CITY PLAN COMMISSION STAFF REPORT

Project Name
Tiffany Square Final Plat

Request
CLD-FnPlat-2024-00003
Final Plat

Case Number: CLD-FnPlat-2024-00003

Final Plat of:

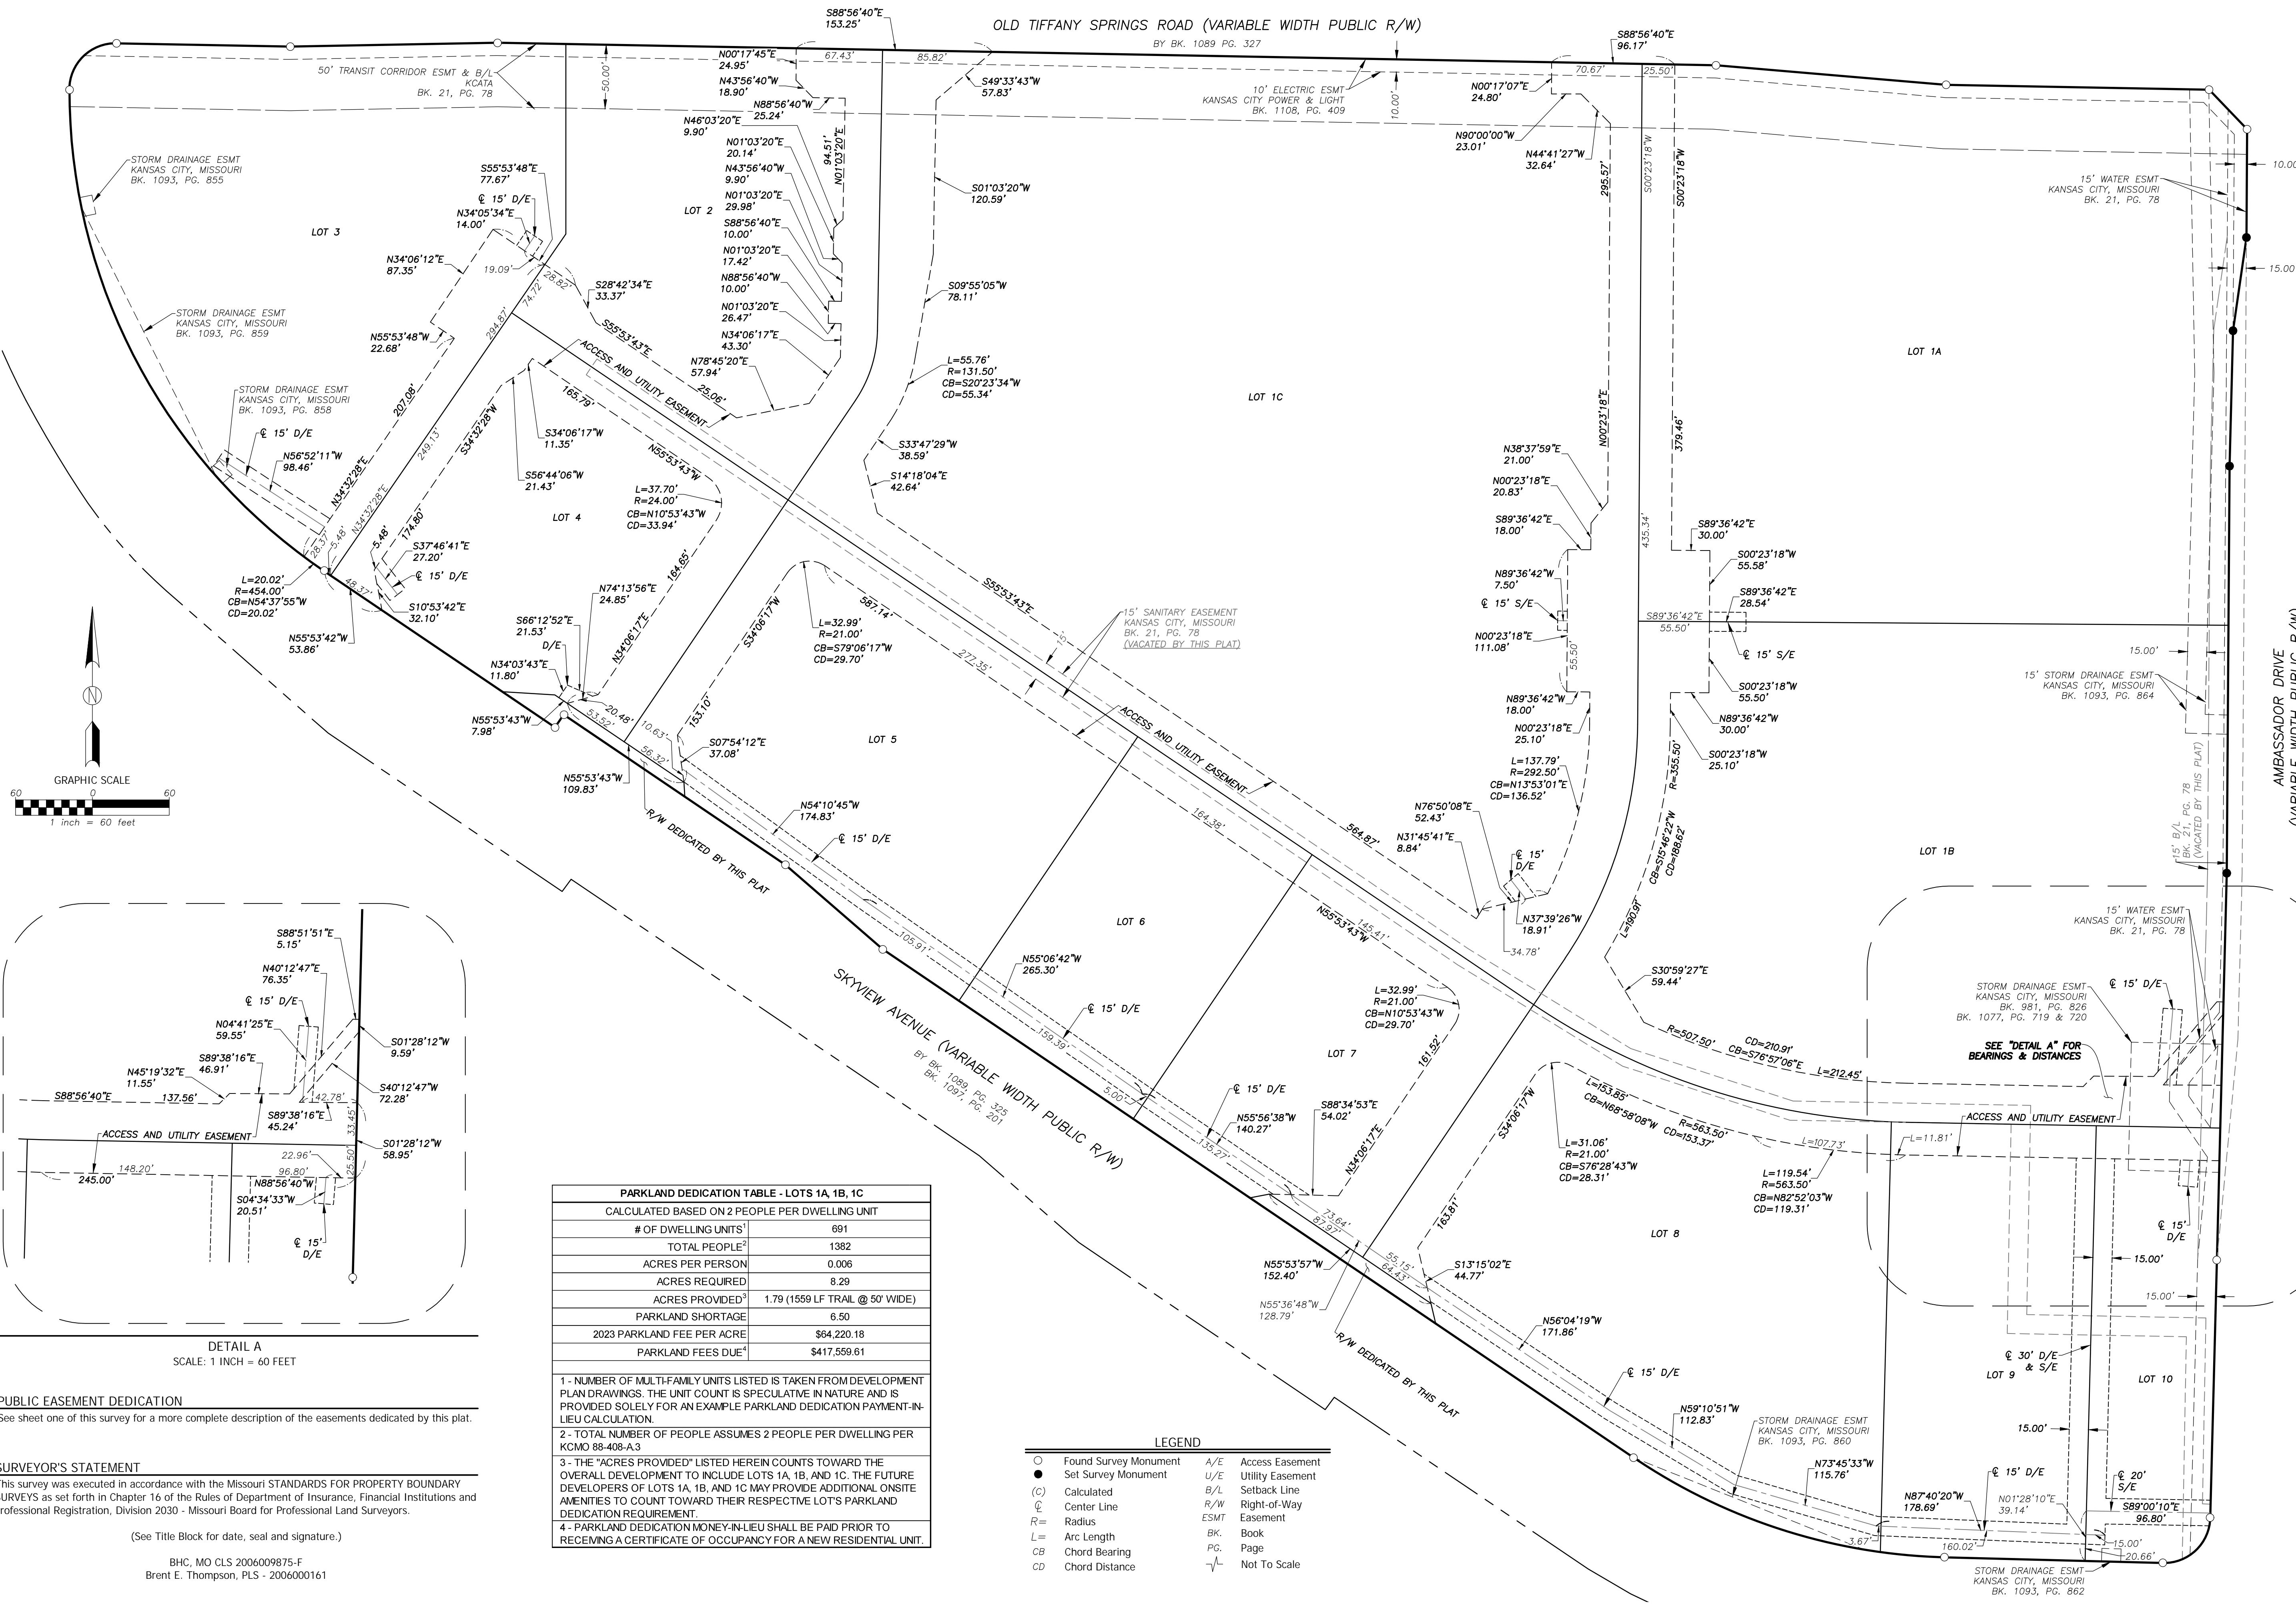
1. That prior to recording of the Final Plat the applicant update the plans to show the County Recorders Block, as found in the Directors Minimal Submittal Requirements, on the first page of the plat.
